Economic Commission for Europe

190th session

Proposal for the 13 series of amendments to UN Regulation No. 13 (Heavy vehicle braking)

Submitted by the Working Party on Automated/Autonomous and Connected Vehicles*

Model A
(See paragraph 4.4. of this Regulation)

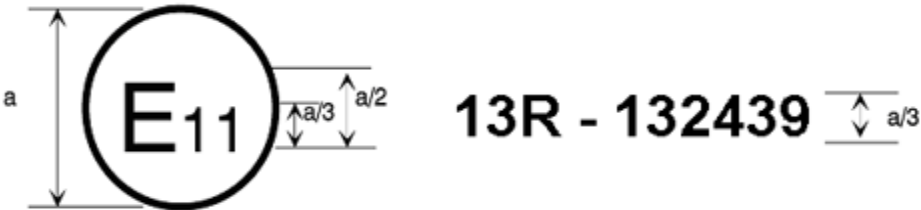
Annex 3, amend to read:

The above approval mark affixed to a vehicle shows that the vehicle type concerned has, with regard to braking, been approved in the United Kingdom (E 11) pursuant to Regulation No. 13 under approval number 132439. This number indicates that the approval was given in accordance with the requirements of Regulation No. 13 with the 13 series of amendments incorporated. For vehicles of categories M₂ and M₃, this mark means that that type of vehicle has undergone the Type-II test.

Model B
(See paragraph 4.5. of this Regulation)

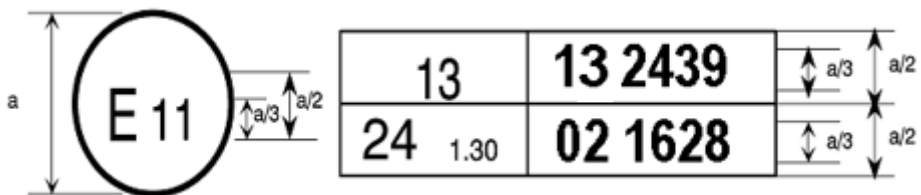
The above approval mark affixed to a vehicle shows that the vehicle type concerned has, with regard to braking, been approved in the United Kingdom (E 11) pursuant to Regulation No. 13. For vehicles of categories M₂ and M₃, this mark means that the type of vehicle has undergone the Type-IIA test.
